U.S. Department
of Transportation
**Federal Highway
Administration**

October 4, 2005

In your September 2 letter to Mr. Richard Powers of my staff, you requested formal Federal Highway Administration acceptance of a design concept by which your Brifen Wire Rope Safety Fence (WRSF) could be transitioned and connected to a strong-post W-beam or Thrie-beam guardrail.

Dwg. No. wrsf-05-210a

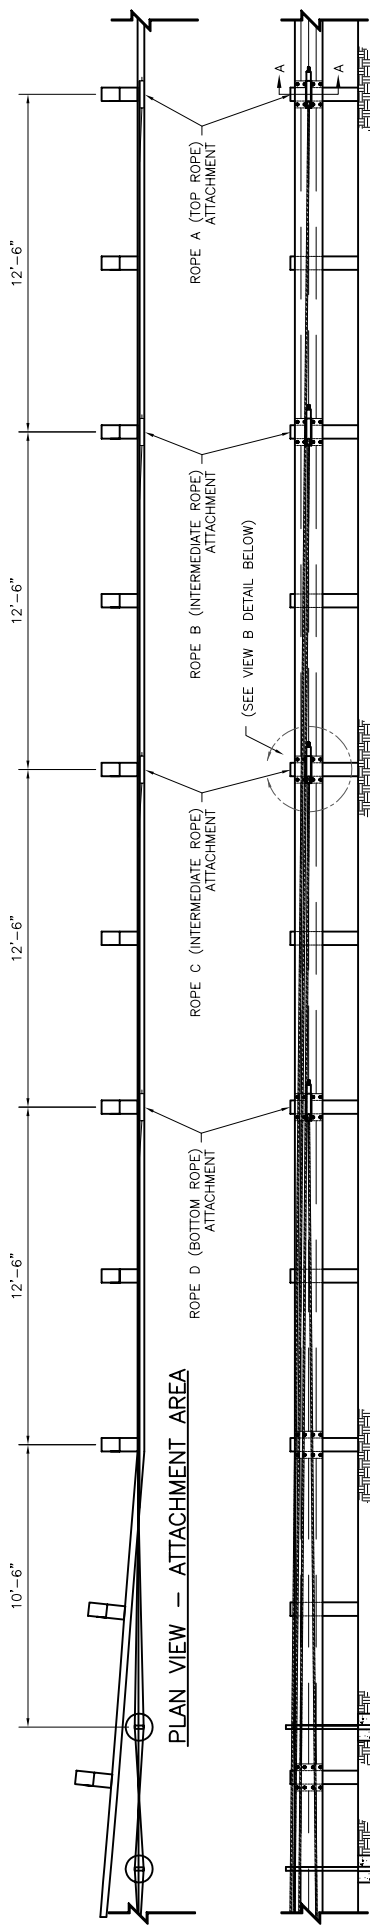
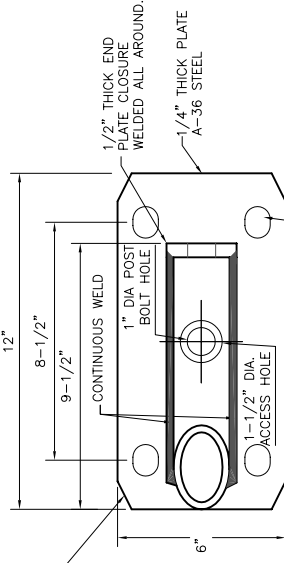
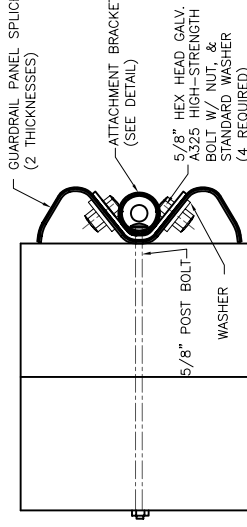
The Brifen WRSF to W-Beam Transition was submitted for acceptance for use in front of standard W-beam terminals having a 4'-0" minimum offset behind the 4-cable pre-stretched and tensioned Brifen system. The 4-cable transition requires four 12-gauge W-beam rail elements 12'-6" long, beginning at the first standard line post in the barrier installation. A unique Brifen attachment bracket is bolted to the rail at each of the first four W-beam rail splice locations and one cable is anchored at each of these brackets. For your 3-cable WRSF, three 12.5' W-beam rail elements and attachment brackets are used. The first WRSF post is placed 10.5' upstream from the first standard guardrail line post at which the lowest cable is connected to the W-beam. The upstream WRSF transition then consists of 16 additional line posts set on 5.25' centers, at which point the standard WRSF post spacing (10.5' or other) begins. Details for the 4-cable, 10.5' post spacing WRSF transition are shown in the enclosed drawing.

Attachment to Thrie-beam guardrail is similar to that shown for W-beam except that, for your 4-cable system, two attachment brackets are located at the first splice and two are located at the second splice. The top and second cables are connected to the brackets in the upper valley (top cable at second splice) and the third and bottom cables are attached to the brackets in the lower valley (bottom cable at first splice). For your 3-cable WRSF the top two cables are attached to the two upper valley brackets (top cable at second splice) and the bottom cable is attached in the lower valley at the first splice location. As with W-beam, all attachments must be at a splice.

Previous full-scale crash testing has shown that the high tension and pre-stretched cables of the Brifen WRSF result in lower deflections than those seen in the lesser-tensioned generic cable barrier. In earlier cable-to-W-beam transition testing with the lower-tensioned generic cable rail, the cable deflection allowed the W-beam terminals to be impacted, resulting in significant vehicle instability. With the Brifen WRSF design, it is less likely that the nose of the terminal will be impacted in a typical design impact. Even so, the use of a lightweight, non-energy absorbing W-beam terminal is suggested to minimize vehicle instability if the terminal is hit.

Based on the specific design details noted above, the Brifen WRSF to W-Beam or Thrie Beam Transitions may be considered acceptable for use on the National Highway System at National Cooperative Highway Research Program Report 350 test level 3 when used in conjunction with a crashworthy terminal having a minimum 4-foot offset from the cables. The design may also be used to connect the WRSF to a weak post W-beam installation when the W-beam is adequately anchored with a crashworthy terminal. Since these transition designs have not been physically tested, field installations should be monitored to verify their presumed crashworthiness.
